WEST WHITELAND TOWNSHIP
Planning Commission
Agenda
Tuesday, September 20, 2022
7:00 P.M.

MEMORANDUM

SUBJECT: Westrum Senior Living at West Whiteland
Land development plan

RE: Westrum Senior Living Community
Preliminary / Final Subdivision and Land Development Plan
SSM File 101008.0363

Site Plan Detail, Sheet 5, Land Development Plan: Whitford Property, Inc.

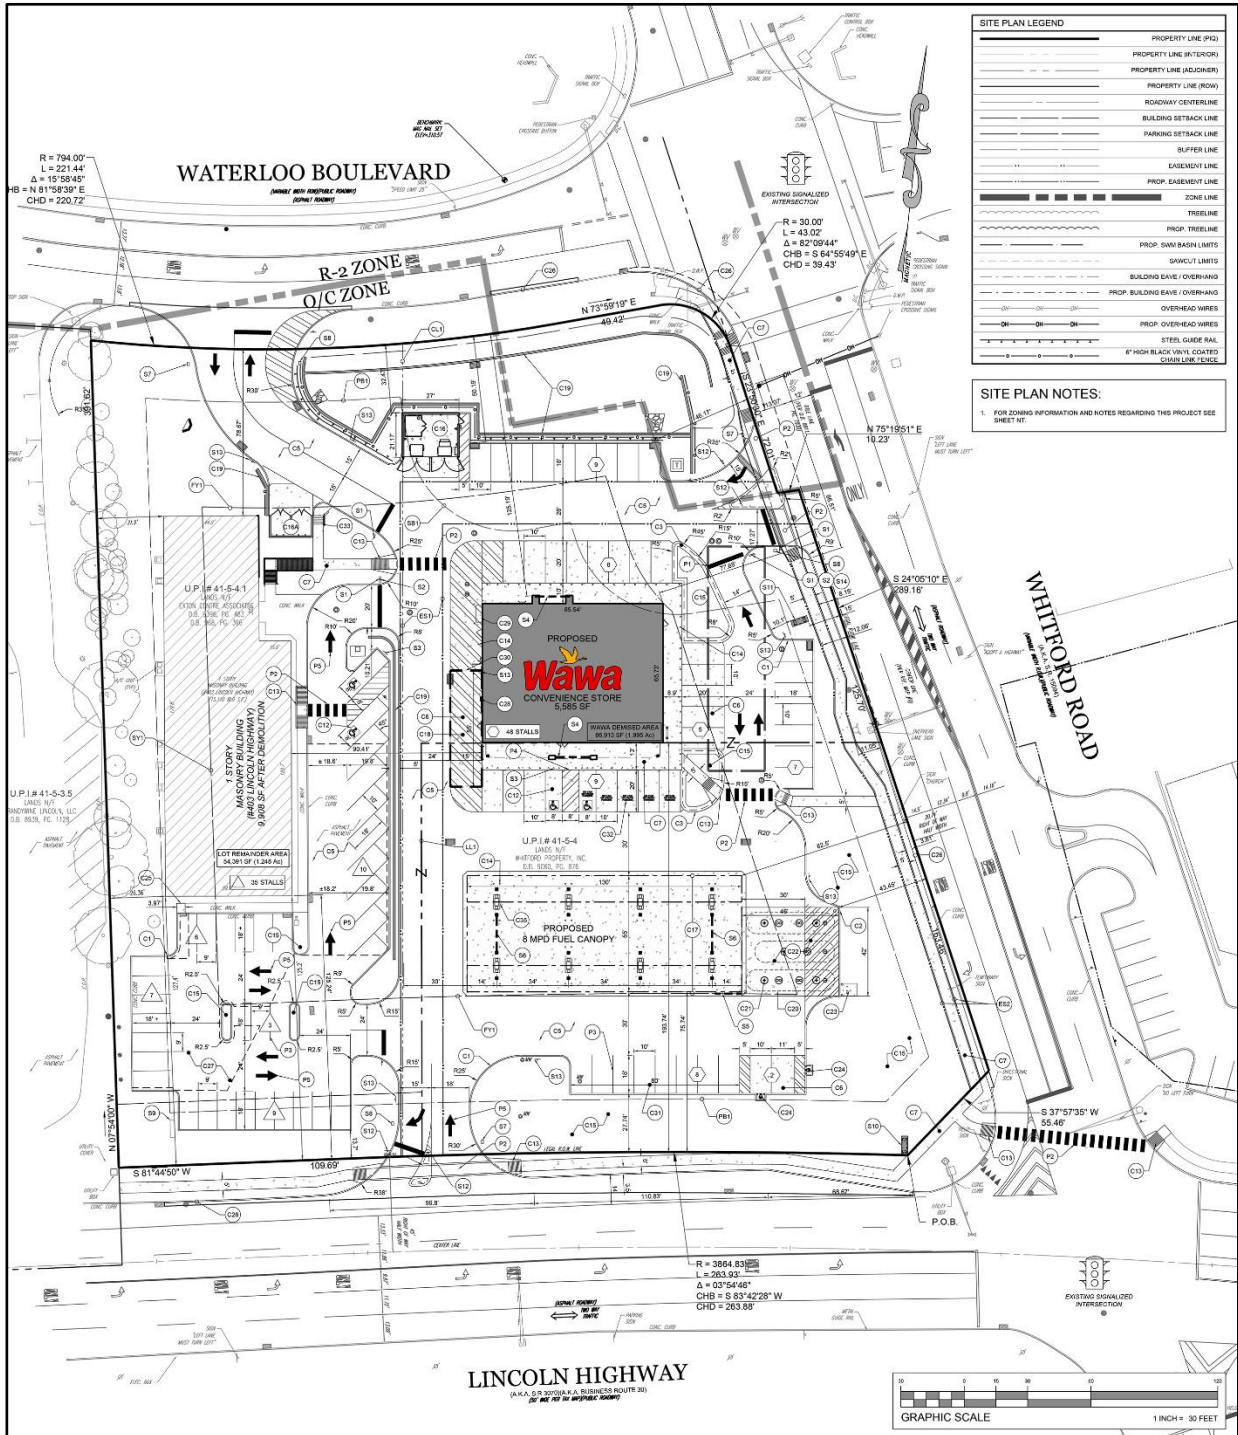
3. The project site is located within the **Suburban Center Landscape** designation of [Landscapes3](#), the 2018 County Comprehensive Plan. The vision for the **Suburban Center Landscape** is regional economic, population and transportation centers with varying land uses, accommodating substantial future growth of medium to high intensity. Repurposing obsolete structures and sites and encouraging sustainable development will be critical as suburban centers grow, and transportation infrastructure and amenities will need to expand to create an integrated multimodal network. The proposed plan submission is consistent with the objectives of the **Suburban Center Landscape**.
